(Last updated: June 7, 2004)

Questions that require an interpretation of the meaning of IEEE-1588 or point out possible errors in the standard are submitted to a subcommittee of the IEEE-1588 working group for formal interpretation following IEEE guidelines. This file is a copy of these interpretations. By IEEE policy these do NOT represent a revision of the standard.

Question 6 continued:

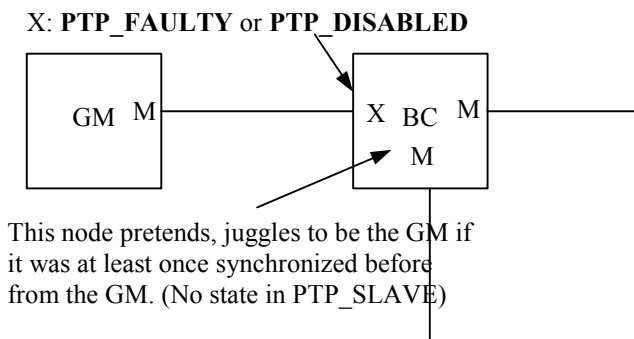
The point here is either the definition of the GM 7.4.4.20/7.5.9 or the clearing of the outdated parent data set. This is due to no port of the BC is in the PTP_SLAVE state. If the clock was synchronized from a GM that does not longer synchronize the BC due to one of the port state either **PTP_DISABLED** or **PTPT_FAULTY**.

Sending a sync message the respective port of a BC verifies whether there is a port in the PTP_SLAVE state. In this scenario there is no port in **PTP_SLAVE** state because the port that was connected to the GM is either in the **PTP_FAULTY** or **PTP_DISABLED** state. (The definition of a Grandmaster Clock in 7.4.4.20 and 7.5.9 "A clock is the GM clock of a subdomain if it has no ports in the PTP_SLAVE state."). This results that the BC transmits sync messages, which *pretend –mock – to be a "living" GM*.

Another solution, which I think will be the best, is to **redefine** the **Grandmaster Definition** of 7.4.4.20 and 7.5.9.

A Clock is a GM clock if all ports are either in the PTP_MASTER, PTP_PASSIVE or PTP_PRE_MASTER state.

This last picture and its comment will not occur if the recommendation above to interpret a transition into either the **PTP_FAULTY** or **PTP_DISABLED** states results in a reinitialization of the parent data set as noted. The proposed change of definition of Grandmaster will not solve the problem. The key to the operation of the protocol state machine is the contents of the data sets, in particular the port configuration data set (where the port state is maintained), the parent data set and the default data set. Of these the port and parent data sets are the ones subject to update based on the protocol state machine (including transitions to faulty and disabled as noted above) and which are the key to determining the correct content of any Sync messages sent. The notion of Grandmaster is something DERIVED from this information and not the root cause. It is the data sets that drive all decision, not the fact that a particular clock is a grandmaster. The statement at several places in the standard that the grandmaster clock has no ports in the PTP_SLAVE state is correct. For example a boundary clock with all ports disabled, faulty or passive is the grandmaster for all of its ports, however ports in these states do not issue Sync messages and hence such a grandmaster would be in an isolated portion of the subdomain.

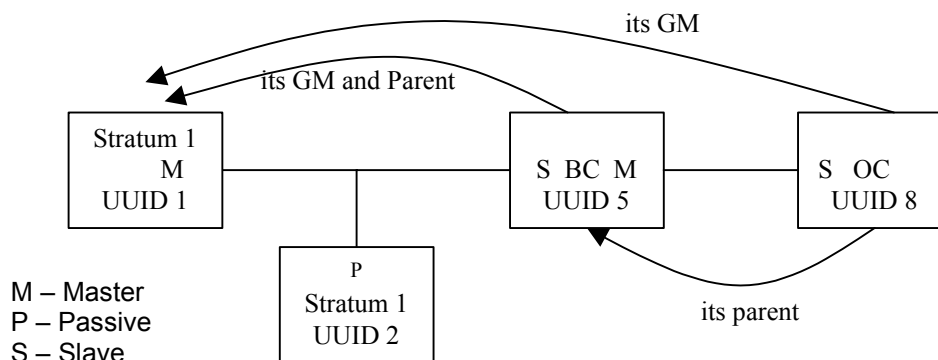
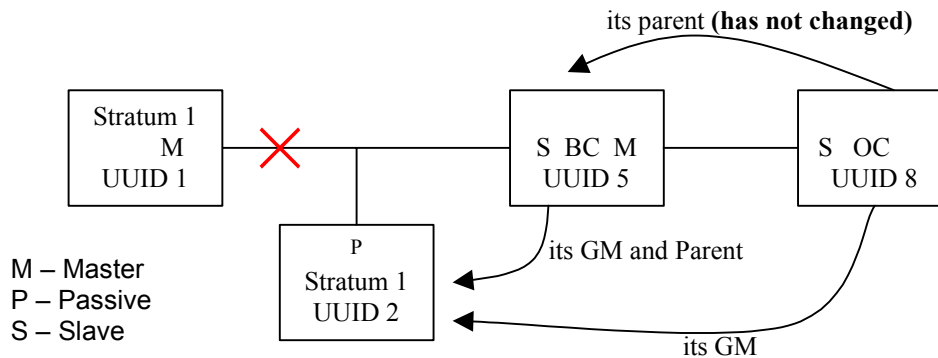
There is a discrepancy in the conditions 7.5.3 and 7.6.2. Consider the following example. Initial condition:

The Ordinary clock with UUID 1 is the grandmaster clock.

If the GM clock UUID 1 fails or the link, the boundary clock (UUID 5) recognizes this after PTP_SYNC_RECEIPT_TIMEOUT and changes its state to PTP_MASTER. The same does the stratum 1 ordinary clock UUID 2. The BMC computes the new states and sets the state of the stratum 1 UUID 2 clock to PTP_MASTER and the BC UUID clock to PTP_SLAVE. For the ordinary clock UUID 8 the parent has not changed only the GM. The following figure illustrates this scenario.

Assume that the grandmasterSequenceId field of UUID 1 is 100 and the grandmasterSequenceId field of UUID 2 is 10.

The problem is the following, if we follow 7.5.3 receipt of a sync message from another clock, the parent data set is **updated**. But the received sync message from the BC by the OC UUID 8 is **not qualified** due to the grandmasterSequenceId of the last qualified sync message is 100 (namely the grandmasterSequenceId from UUID 1) and the grandmasterSequenceId of the current sync message is 10. After 90 sync messages the sync messages will overcome this problem due to the grandmasterSequenceId.

The problem is with the definition of 'most recent', which is only applied when comparing two messages received on a given receiving port of the receiving clock and sent from the same port on the same sending clock. As noted by the questioner, clause 7.6.2 imposes two 'Ored' conditions on the compared messages. One based on grandmasterSequenceId and the other on grandmasterSequenceIds and sequenceId. As stated this definition may lead to problems with symptoms similar to those noted by the questioner although not for the reasons given.

Since the most 'recent' message sent by a port is defined by the sequenceId assigned by the sending port the last section of 7.6.2 starting with "A Sync message A is more recent than a Sync message B if" should read:

“When comparing two messages received from the same sending port, the message with the greatest value of sequenceId appropriately taking into account the rollover properties of the datatype is the most recent”.

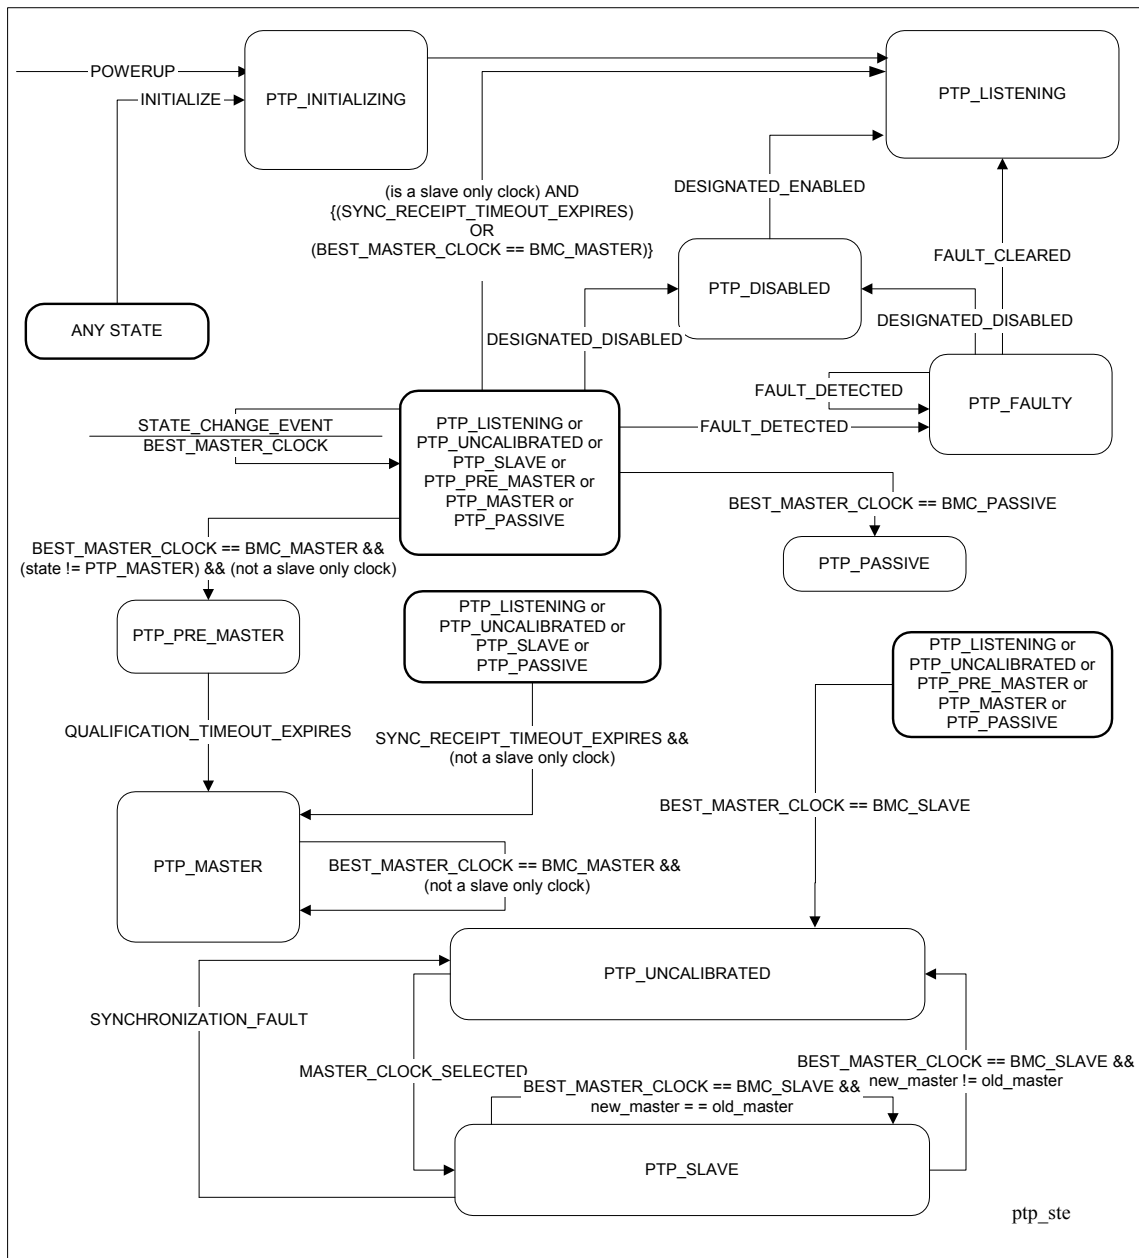
There is an event in the Protocol Engine State Machine that I can't find a definition for:

- SYNCHRONIZATION_FAULT

This seems like the SYNC_RECEIPT_TIMEOUT_EXPIRES event, but that defined event already causes a transition from PTP_SLAVE to PTP_MASTER. SO...it seems like the SYNCHRONIZATION_FAULT event is really the SYNC_RECEIPT_TIMEOUT_EXPIRES when the clock is "slave only"? Regardless, the event needs a definition.

Looking closer, it also seems like there is some bouncing around between states when the 'current master' goes away. A PTP_SLAVE detects the timeout, goes to PTP_MASTER, runs the STATE_CHANGE_EVENT and goes to PTP_PRE_MASTER, and then either goes to PTP_MASTER again or heads off to PTP_UNCALIBRATED. That first transition to PTP_MASTER has me a bit confused, based on events afterward.

There is also the possibility of thrashing for any clock in the PTP_MASTER state due to an ambiguity in the definition of what constitutes a STATE_CHANGE_EVENT clause 7.5.8 and the state diagram of Figure 9. The STATE_CHANGE_EVENT causes the best master clock algorithm to execute. The common condition for a clock in the PTP_MASTER state when this occurs is for the Recommended State (of Figure 9) to be PTP_MASTER presumably causing the clock to remain in the PTP_MASTER state. Yet Figure 9 requires the clock to go to the PTP_PRE_MASTER state. This is incorrect. Figure 9 should indicate that the clock remains in the PTP_MASTER state.

In a future revision Figure 9 should be modified to the version shown below.
